Access Compliance Report Public Rights-of-Way (Curb Ramps)

Intersection ID: N/AMain Street: E_TRADE_STCross Street: N/ALocation: NWADA ID: A70A4FD54B72Ramp Type: PerpInitial Pass/Fail: Pass Overall Compliance: No Severity Score: 5.25

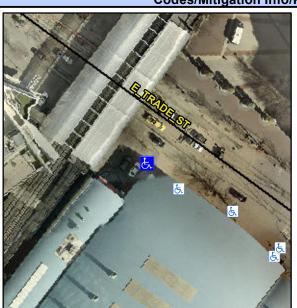
Field Measurements/Component Compilance					
Compliance Description		Data	Compliance Description		Data
N/A	Ramp Length (in)	24.0	Yes	Ramp Slope (%)	7.0
Yes	Ramp Width (in)	48.0	Yes	Ramp XSlope (%)	3.6
N/A	Flare Type LT	Sloped	N/A	Flare Type RT	N/A
N/A	Flare Slope LT (%)	3.7	No	Flare Slope RT (%)	13.7
N/A	Flare Traversable LT?	Yes	N/A	Flare Traversable RT?	Yes
Yes	Landing Length (in)	48.0	Yes	DWS Provided?	Yes
Yes	Landing Width (in)	48.0	Yes	DWS Contrast?	Yes
No	Landing Slope (%)	3.4	Yes	DWS Length (in)	24.0
Yes	Landing X Slope (%)	3.0	Yes	DWS Full Width?	Yes
N/A	Landing Curb? (Y/N)	No	Yes	DWS Offset (in)	0.0
N/A	Shared Landing?	No			
Yes	Gutter Ponding?	No	Yes	Gutter Slope (%)	1.9
Yes	Gutter Lip Ht (in)	0.0	Yes	Gutter X Slope (%)	4.0
N/A	Painted X Walk1?	No	N/A	Painted X Walk2?	N/A
	X Walk 1 Direction	To SE		X Walk 2 Direction	N/A
N/A	X Walk 1 Width (in)	N/A	N/A	X Walk 2 Width (in)	N/A
	X Walk 1 Slope (%)	0.1		X Walk 2 Slope (%)	N/A

X Walk 1 X Slope (%)	4.6		X Walk 2 X Slope (%)	N/A
N/A	Ramp inside XWalk1?	N/A	N/A	Ramp inside XWalk2?	N/A
	Road Slope (%)	N/A	N/A	Clear Space?	Yes
	Road X Slope (%)	N/A	N/A	Clear Space to XWalk (in)	N/A
Yes	Any Obstructions?	No	Yes	Storm Grate/Utility Hazard?	No
	Obstruction Type			Storm Grate/Utility Type	
		N/A			N/A
			Yes	Surface Condition? (G/P)	Good

Remove & Replace Entire Ramp.
